IEEE P802.15
Wireless Personal Area Networks

Project	IEEE P802.15 Working Group for Wireless Personal Area Networks (WPANs)	
Title	Spectral mask for FSK	
Date Submitted	[June, 2010]	
Source	[James P. K. Gilb] [SiBEAM] [555 N. Mathilda, Suite 100, Sunnyvale, CA 94085]	Voice: [408-245-3120] Fax: [408-245-3120] E-mail: [last name at ieee dot org]
Re:	[d1P802-15-4g_Draft_Standard.pdf]	
Abstract	[This document describes changes to add an FSK mask to the draft.]	
Purpose	[To resolve comments in LB51.]	
Notice	This document has been prepared to assist the IEEE P802.15. It is offered as a basis for discussion and is not binding on the contributing individual(s) or organization(s). The material in this document is subject to change in form and content after further study. The contributor(s) reserve(s) the right to add, amend or withdraw material contained herein.	
Release	The contributor acknowledges and accepts that this contribution becomes the property of IEEE and may be made publicly available by P802.15.

2.1 Comment resolution items for FSK/GFSK

2.2 Comments resolution for TX spectral mask and modulation accuracy.

Figure 2—2-FSK modulation

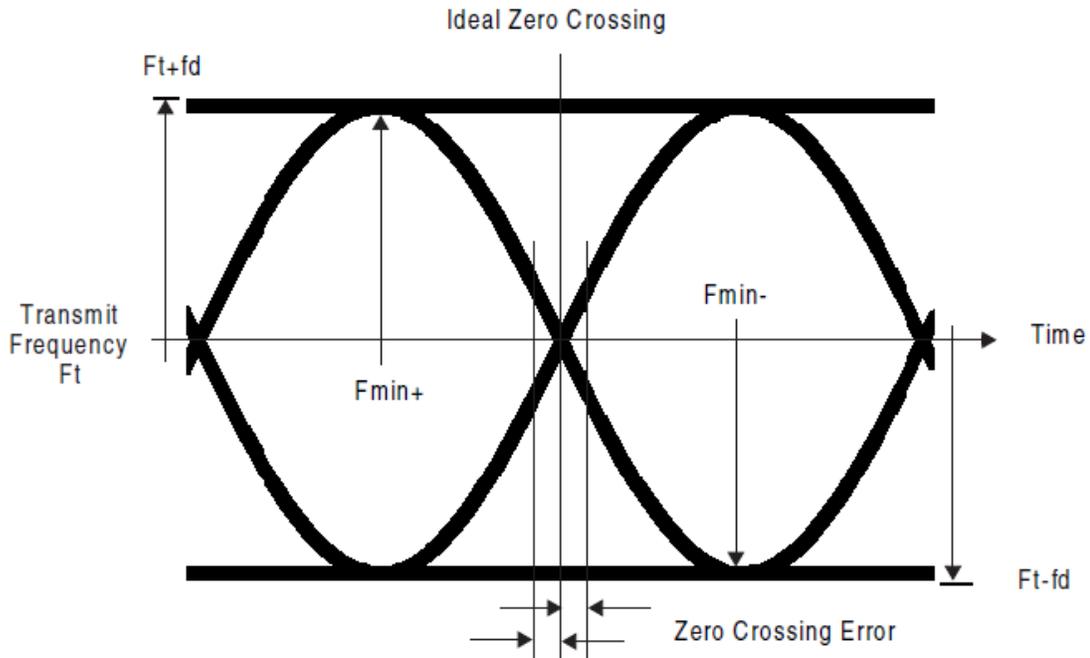
The symbols and terms for 2-FSK signal is illustrated in Figure 2.

For 2-FSK, the error in the modulation, $\Delta f d$, at mid-symbol time shall be less than

- $\pm 0.2 * \Delta f$ for modulation indexes less than or equal to 0.5,
- $\pm 0.3 * \Delta f$ for modulation indexes greater than 0.5,

The zero crossing error shall be less than $\pm 1/8$ of a symbol period.

Figure 3—4-FSK modulation

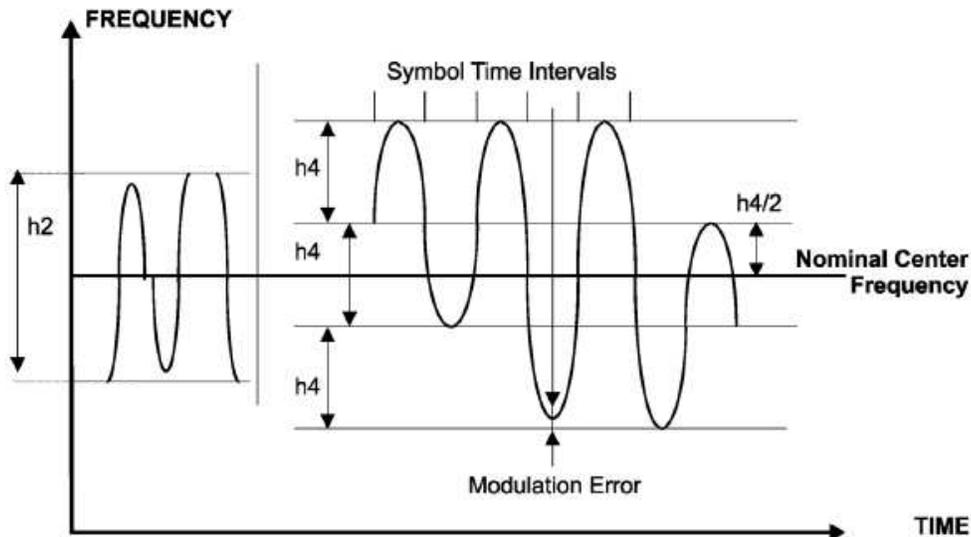
The symbols and terms for 4-FSK are illustrated in Figure 3.

For 4-FSK, the error in the modulation at mid-symbol time shall be less than $\pm 0.2 * \Delta f$, where Δf is defined in 6.12a.1.2.
